SUBJECT: Forwards addl response to 820730, 0916 & 830810 requests for
 info on hydrogen combustion & control. Info covers capability
 of air return/hydrogen skimmer sys fan & ice condenser doors
 to survive differential pressure loadings

Donald C. Cook Nuclear Plant Unit Nos. 1 and 2
Docket Nos. 50-315 and 50-316
License Nos. DPR-58 and DPR-74
ADDITIONAL RESPONSES TO REQUESTS FOR INFORMATION ON
HYDROGEN COMBUSTION AND CONTROL

ATTACHMENT 1 TO AEP:NRC:0500M
RESPONSES TO QUESTIONS ON HYDROGEN CONTROL
CONTAINED IN MR. S. A. VARGA'S LETTER DATED AUGUST 10, 1983
DONALD C. COOK NUCLEAR PLANT UNIT NOS. 1 AND 2

Figure 1-1
D.C. COOK CLASIX MODEL

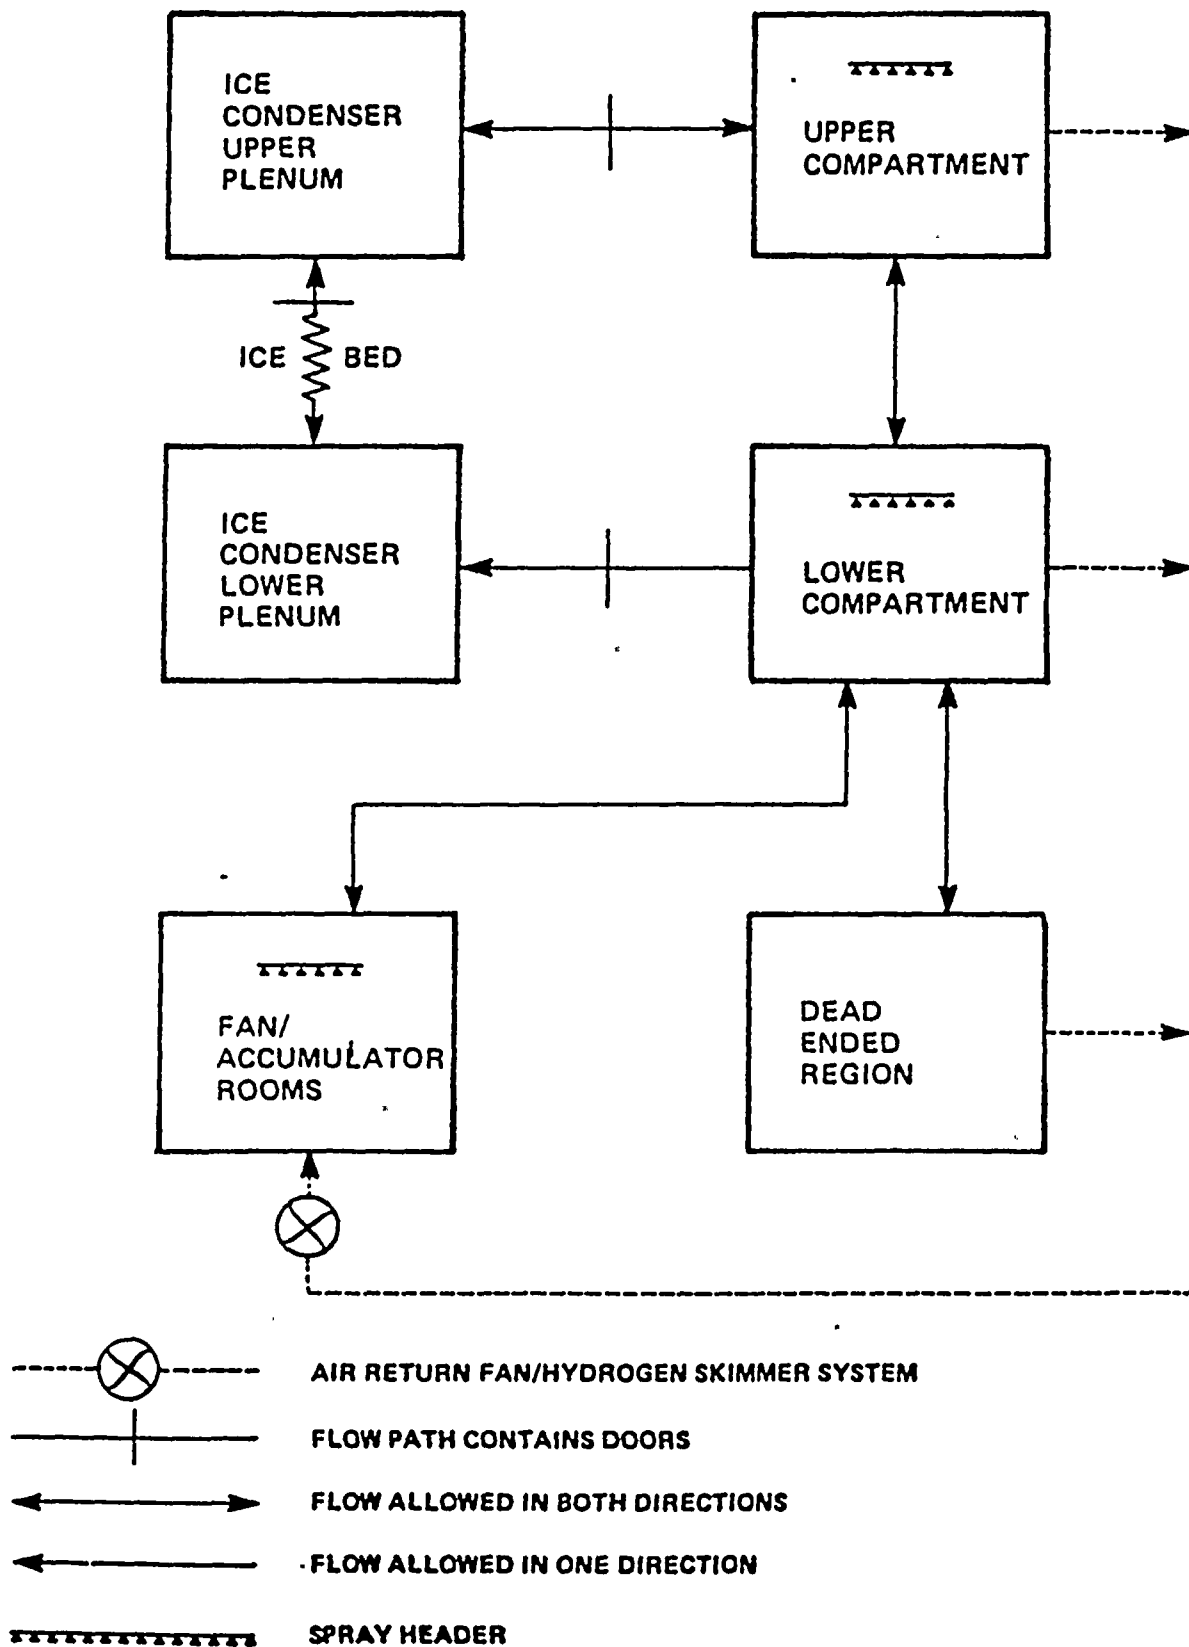
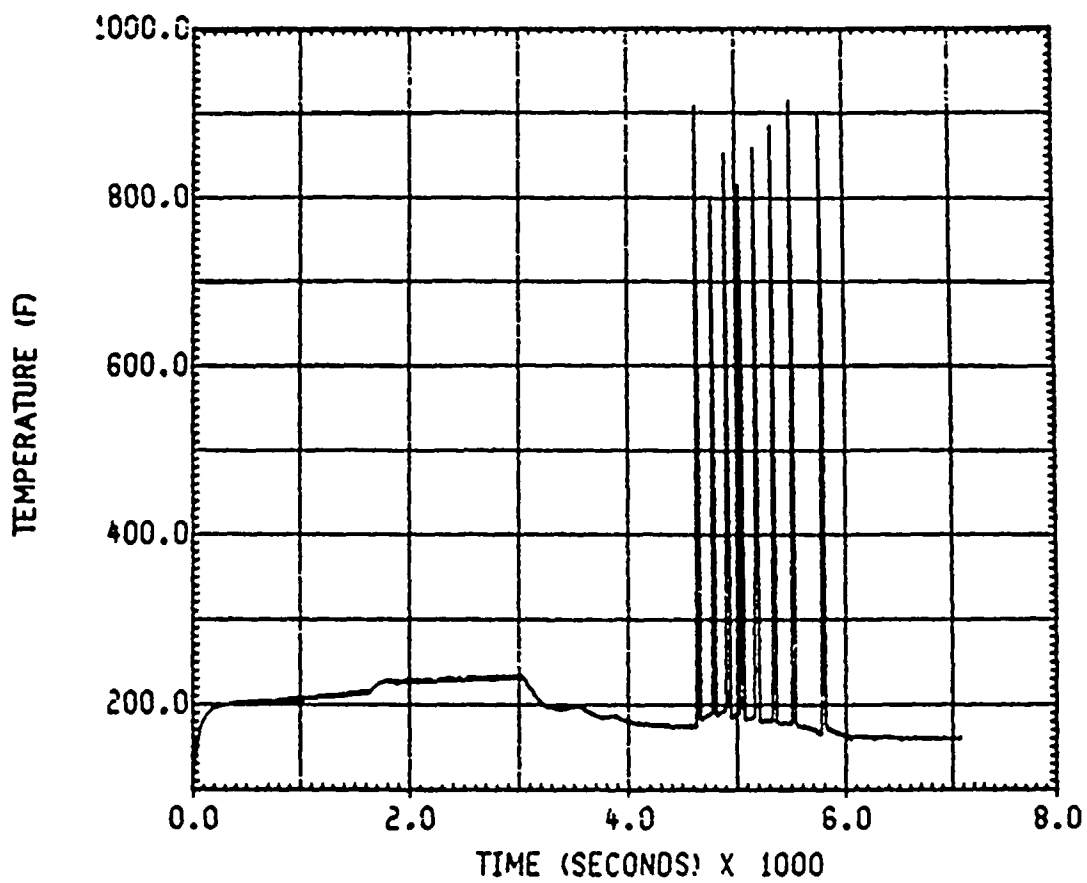
Based on the above discussion, provide justification for the models incorporated in CLASIX or provide the results of analyses with acceptable models as outlined above. The analyses should encompass selected sensitivity studies to assure that the effects of the changes are determined for both containment integrity and equipment survivability considerations.

A schematic diagram of the CLASIX containment model for the Donald C. Cook Nuclear Plant is given in Figure 1-1. Each case was performed using the same input parameters as used for CLASIX Case "C" of Reference (1-2), except for the time step and passive heat sink nodalization. The time step was increased from 0.01 to 0.1 second to reduce computer run time. Due to this time step change, the number of nodes in appropriate wall layers were reduced to maintain stability. Passive heat sink data are given in Tables 1-1 through 1-8 and reflect the noding changes. Also, due to the slightly different pressure response obtained by using the Uchida correlation, the fan and spray initiation time increased since the 3.0 psig set point was reached later in the transient. The spray initiation time increased from 141 to 190 seconds, while the air return fan/hydrogen skimmer system initiation time increased from 711 to 760 seconds.

Figure 2-1. Spray mass vaporization during a CLASIX upper compartment burn.

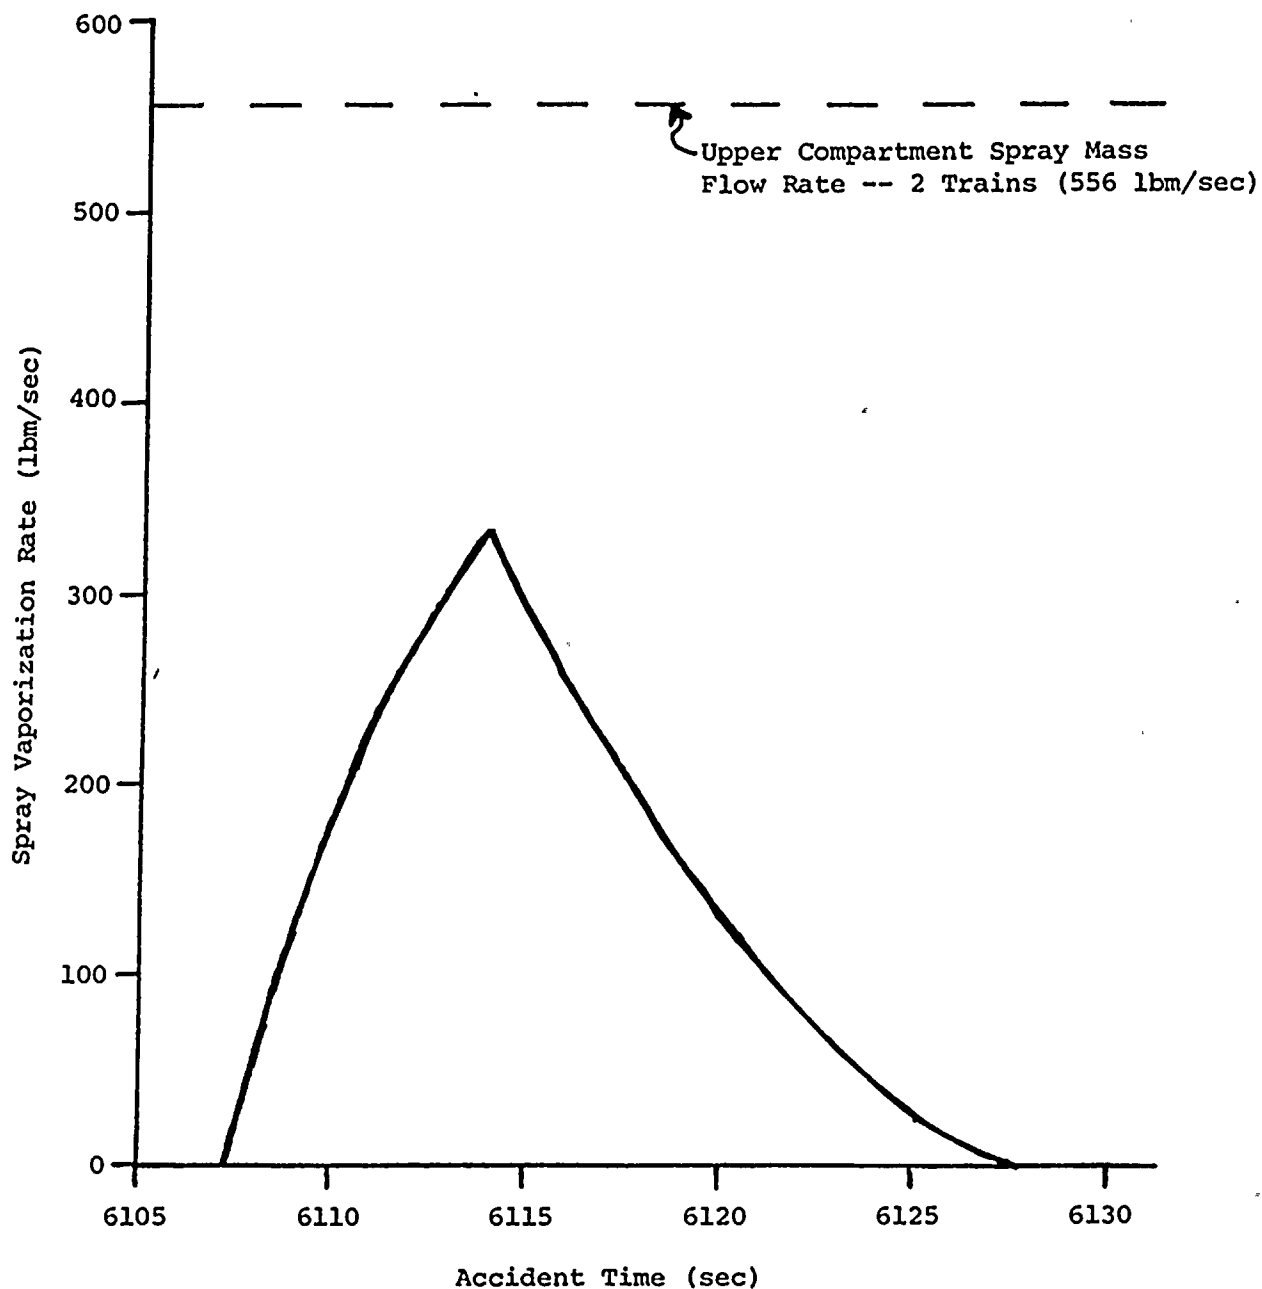
- (a) Provide a quantitative description of the spray heat and mass transfer under containment conditions typical of a hydrogen burn. Include in your response plots of containment temperature, spray heat transfer, spray mass evaporation, and suspended water mass as a function of time for both the CLASIX spray model and a model in which the spray mass is tracked throughout the fall (and allowed to accumulate in the containment atmosphere).
- (b) Provide analyses of spray mass evaporation and pressure suppression effects for an upper compartment burn.
- (c) Justify the drop film coefficient value used in the spray model analyses ($20 \text{ Btu/hr-ft}^2\text{-}^\circ\text{F}$) and discuss the effect of using a constant value throughout a burn transient.

Based on a total spray mass flow rate of 556 lbm/sec for the Donald C. Cook Nuclear Plant upper compartment, the rate of spray mass vaporization has thus been calculated for this case. The values obtained from this analysis are presented in the last column of Table 2-1, and are plotted in Figure 2-1. The results indicate that a peak spray mass vaporization rate of 330 lbm/sec will be reached at the time of peak compartment temperature and pressure.
